ENGINEERING JUDGMENT FIRESTOP DETAIL

PROJECT : SAN JOAQUIN COUNTY DISTRICT ATTORNEY OFFICE
 ADDRESS : 6 S. EL DORADO, STOCKTON, CA 95206

ISSUED TO : DREYFUSS + BLACKFORD ARCHITECTURE

Drawing No.
663569a

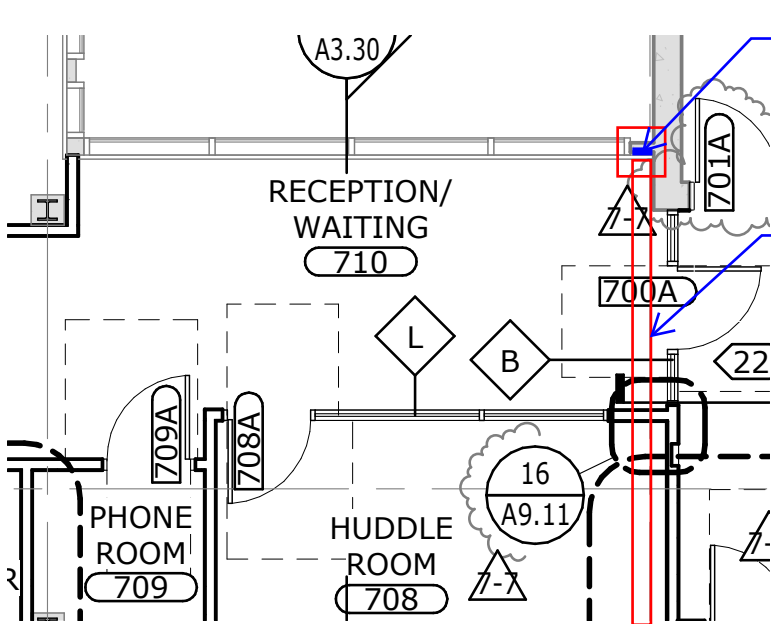
Existing accordion fabric runs up the the entire 7 story building at the seismic joint. We have no spec on it.

Can the Hilti firestop joint spray lap up the accordion fabric?
